CITY OF ALBUQUERQUE

Re: Broadstone Promenade Phase 6

6400 San Pedro Dr. NE Grading and Drainage Plan Permanent CO – Accepted

DRAINAGE CERTIFICATION

OVERALL **GRADING AND DRAINAGE PLAN**

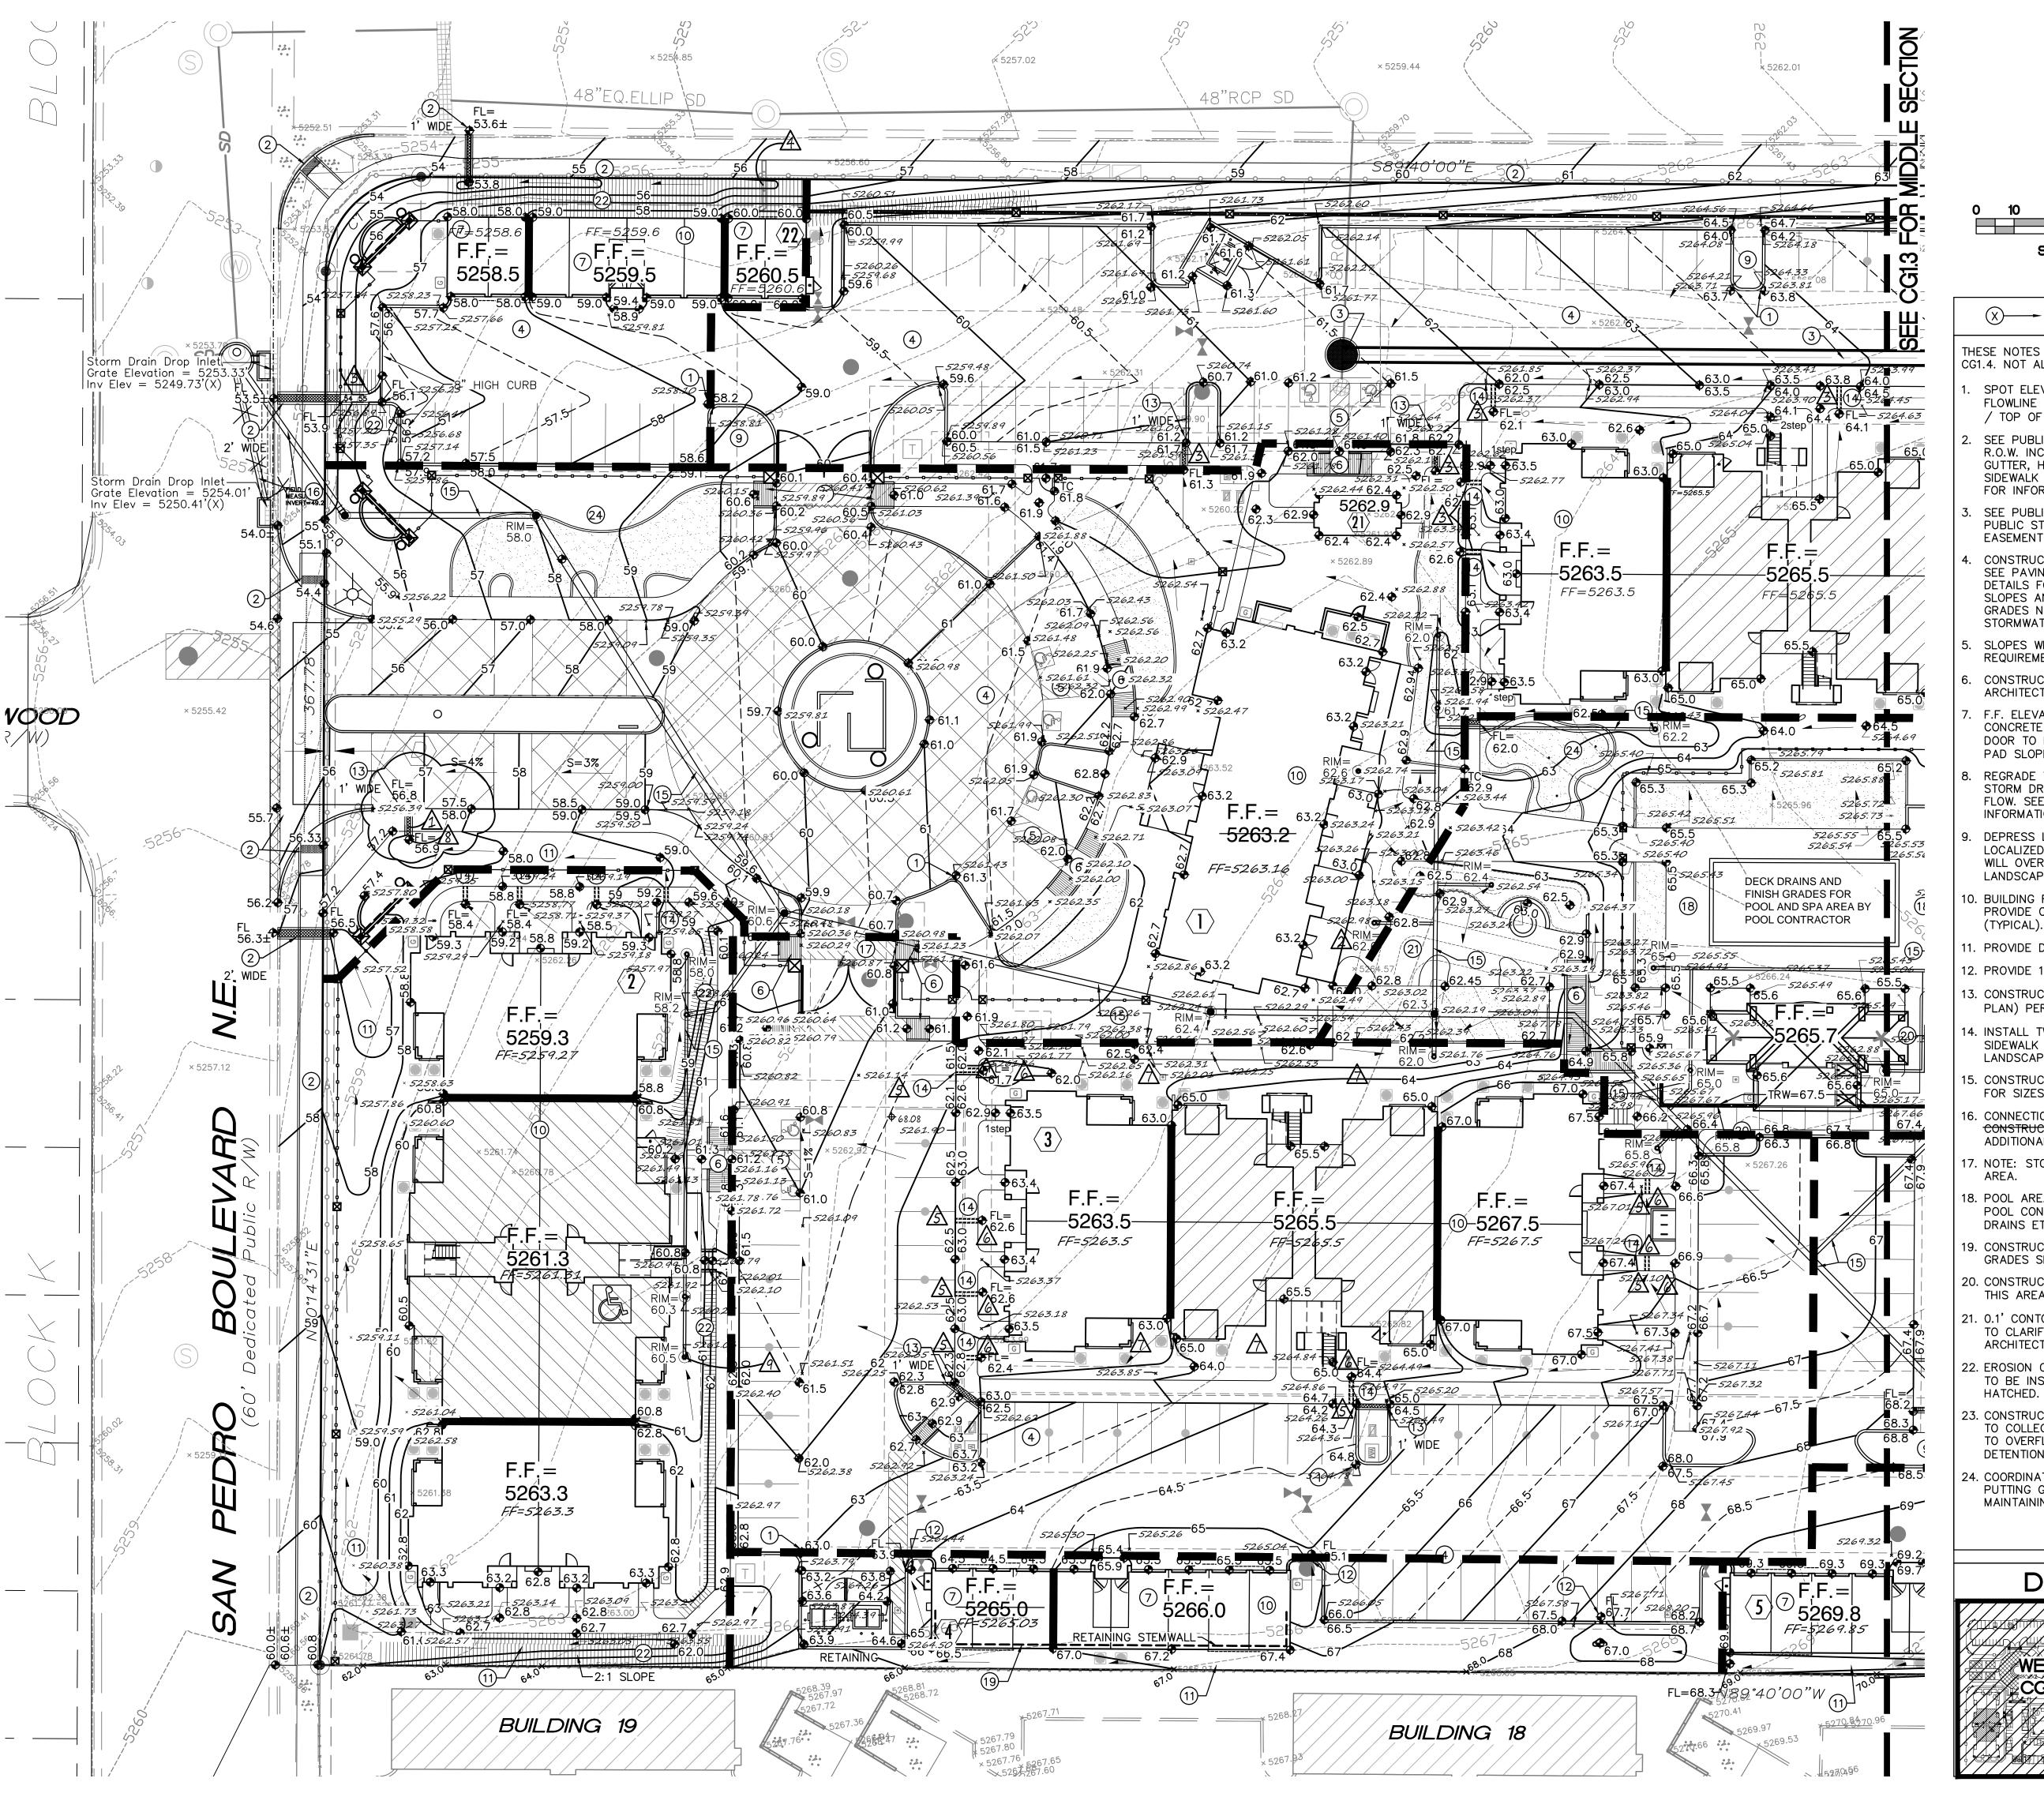
• Make sure swale north of building #2 has positive drainage toward pond at NW corner of building.
